Attached is a copy of the Federal Emergency Management (FEMA) evaluation of the River Bend Station Prompt Alert and Notification Systems confirming that it satisfies the requirements of NUREG-0654/FEMA-REP-1, Revision 1 and FEMA-REP-10.

The Federal Emergency Management Agency (FEMA) has completed an analysis of the prompt alert and notification system for the River Bend Station located near St. Francisville, Louisiana. This review has been completed pursuant to Title 44 CFR, Part 350; selected evaluative criteria and Appendix 3 in NUREG-0654/FEMA-REP-1, Revision 1; and FEMA-REP-10, the "Guide for the Evaluation of Alert and Notification Systems for Nuclear Power Plants." The enclosed report entitled, "River Bend Station Site-Specific Offsite Radiological Emergency Preparedness Alert and Notification System Quality Assurance Verification," summarizes the engineering design review; incorporates the results of the telephone survey of the public conducted immediately following full activation of the alert and notification system on June 25, 1987; and confirms the adequacy of the applicable evaluative criteria from NUREG-0654/FEMA-REP-1, Revision 1, and FEMA-REP-10.

RIVER BEND STATION

FIGURE 2

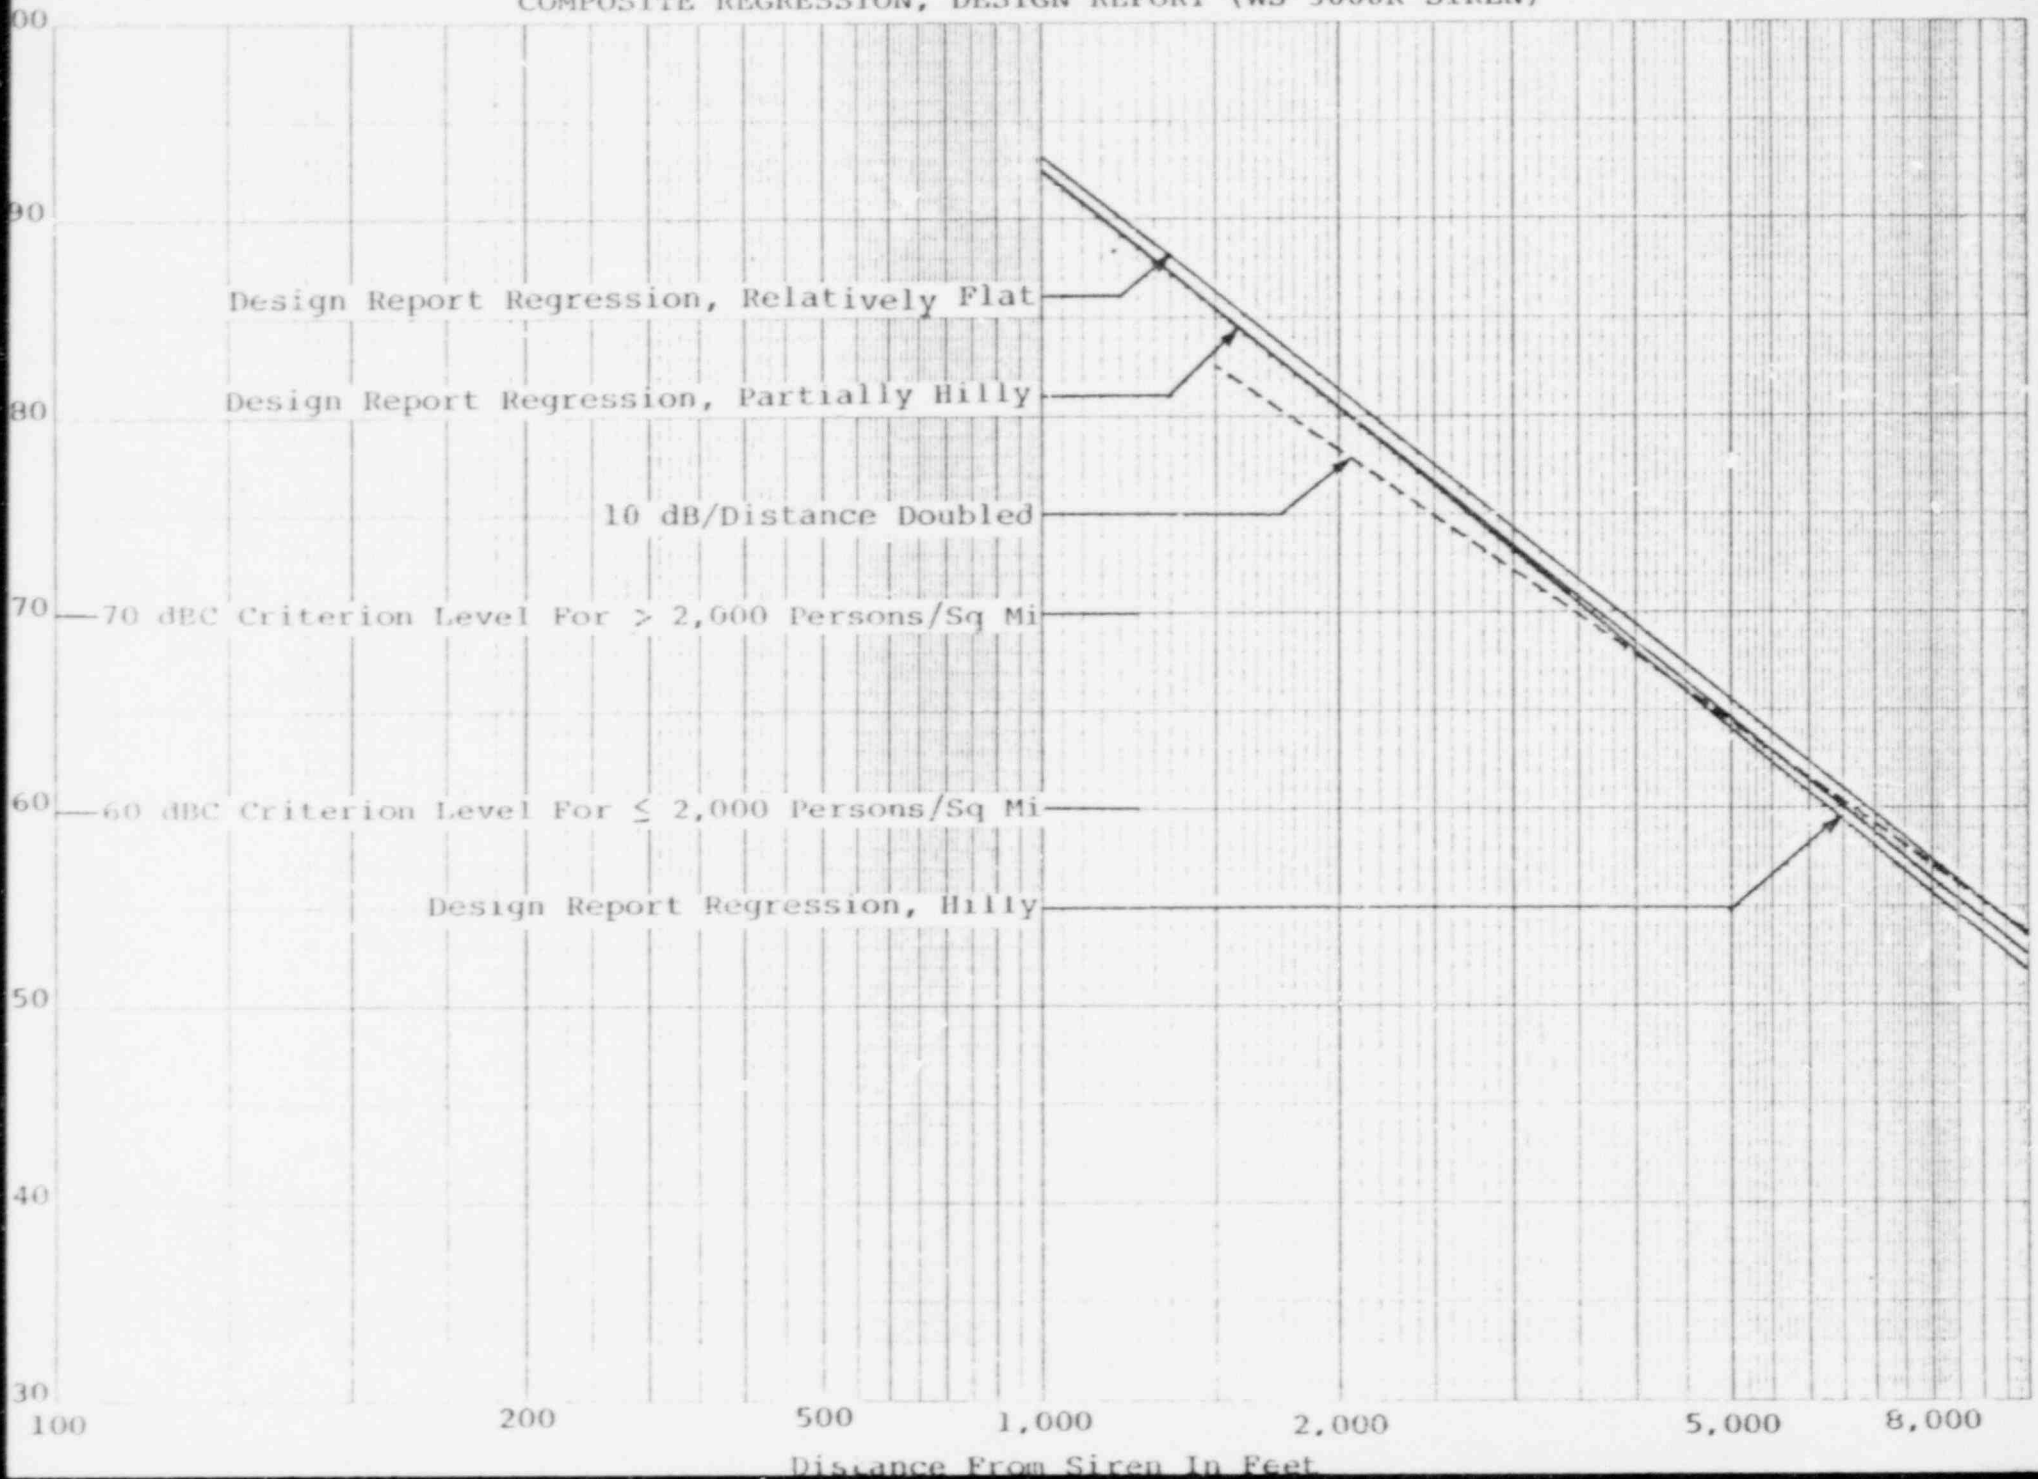
Figure 2 of this report shows the regression data of the Design Report's computer model prediction results for all categories that are characteristic of the site. The 10 dB loss per distance doubled attenuation rate is also included in Figure 3 for comparison. The Design Report's computer model predictions for these 10 sirens yield an apparent sloping rate of 12 dB loss per distance doubled within 1,000 to 10,000 ft. from the siren. The Design Report's results do not show significant difference in siren ranging performance over varied terrain conditions. As shown in Figure 2 of this report, the regression lines of the Design Report's predicted siren sound pressure levels over hilly terrain and those over flat terrain differ very slightly (within 2 dBC).

The Design Report's regression data indicate 60 dBC ranges of from 6,400 to 6,900 ft. and 70 dBC ranges of from 3,600 to 3,900 ft. for the varying site conditions. The 10 dB loss per distance double attenuation rate yields a range of 7,000 ft. for 60 dBC and 3,500 ft. for 70 dBC. Thus, the ranges predicted by the Design Report's model are comparable to the 10 dB loss per distance doubled attenuation rate on a linear regression basis. It must be noted, however, that the 10 dB rule is premised upon a siren operating frequency of 500 Hz, which suffers less transmission loss over large distances in the atmosphere than the higher operating frequency of 700 to 800 Hz of the WS-3000 or WS-3000R sirens.

FIGURE 3

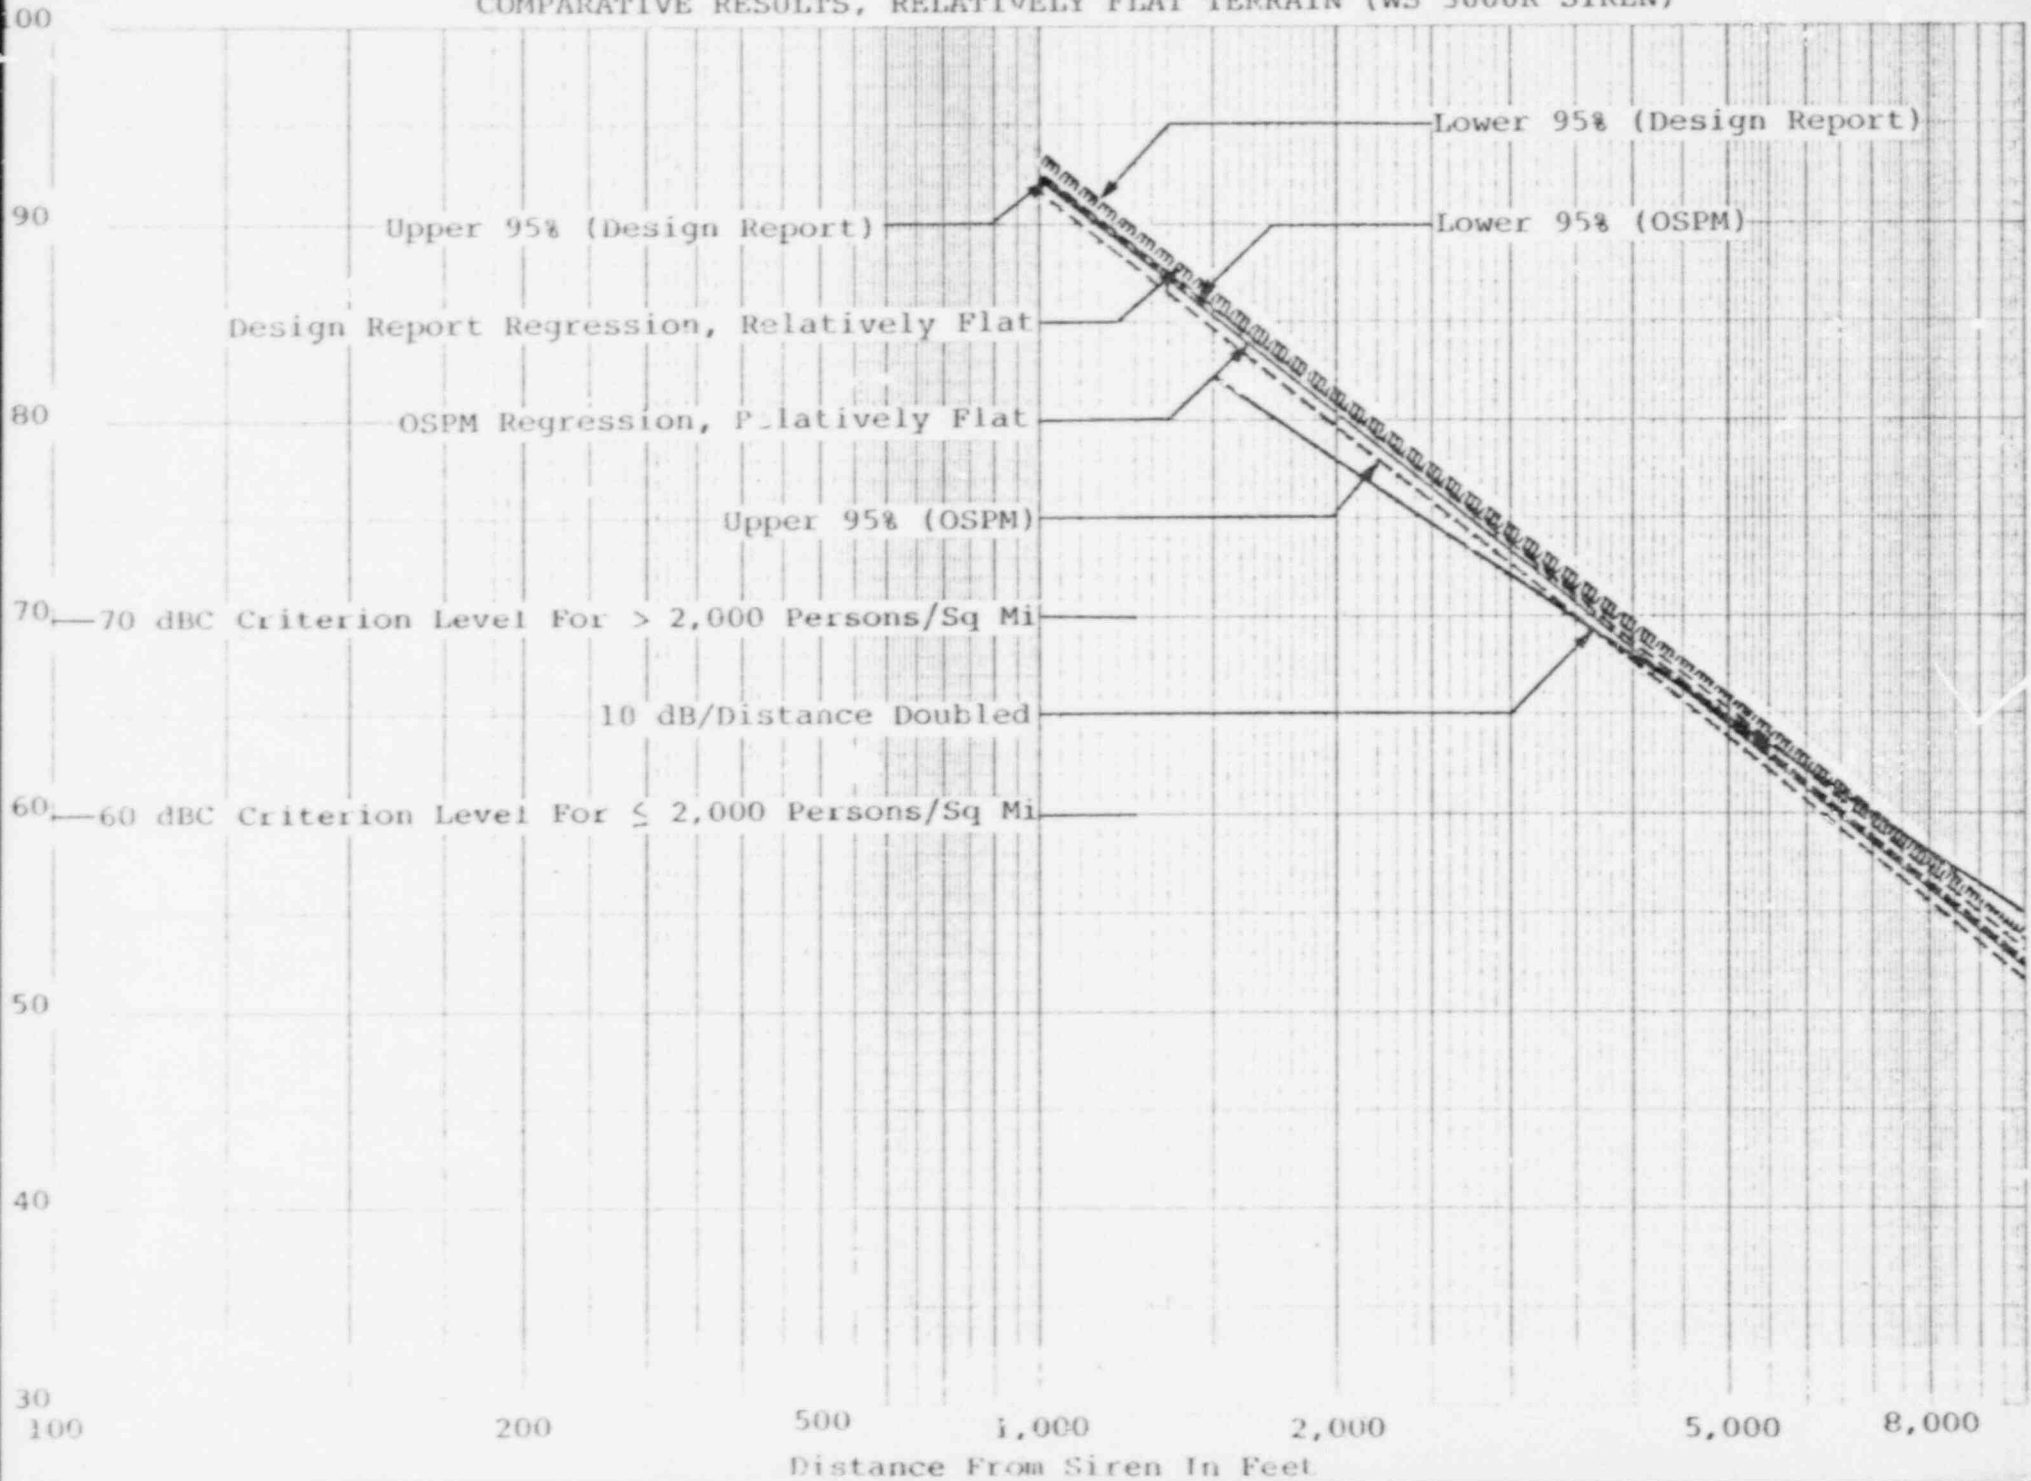
Figures 3 through 5 of this report depict the regressions of OSPM predictions and the Design Report's predictions, along with the 10 dB loss per distance

doubled attenuation rate, for each of the three categories. Some general comparative observations can be made. First, the regressed ranges for 70 and 60 dBC based on the Design Report's data are greater than those of OSPM predictions (by 500 to 700 ft.) over corresponding terrain categories. This is largely due to the higher operating frequency of the sirens with its attendant much higher air absorption losses than those anticipated by the 10 dB rule. Second, the OSPM results show much larger variations in 70 and 60 dBC ranges for propagation paths over various terrain categories, as would be expected. Last, the 60 and 70 dBC ranges estimated by the licensee are liberal over the hilly and partially hilly terrains.
